Response to referee #1's comments

Figure 2. Soil model of the WEB-DHM.

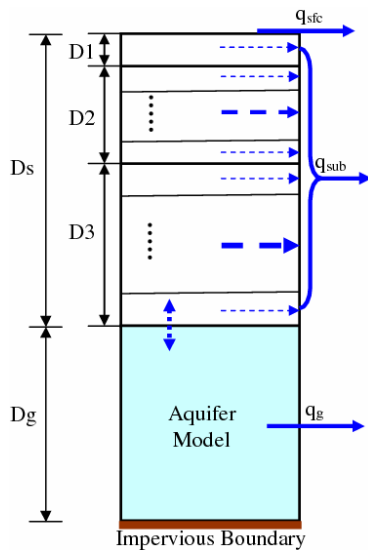
(7) P6906, L5. “top soil depth” should be “total soil depth”?

Answer: The WEB-DHM includes a lumped unconfined aquifer to describe the groundwater dynamics, and the “top soil” represents the soil column above the unconfined aquifer (see [Fig 2 in the revised manuscript](#)). Therefore, it is called as “top soil depth” (D_s).
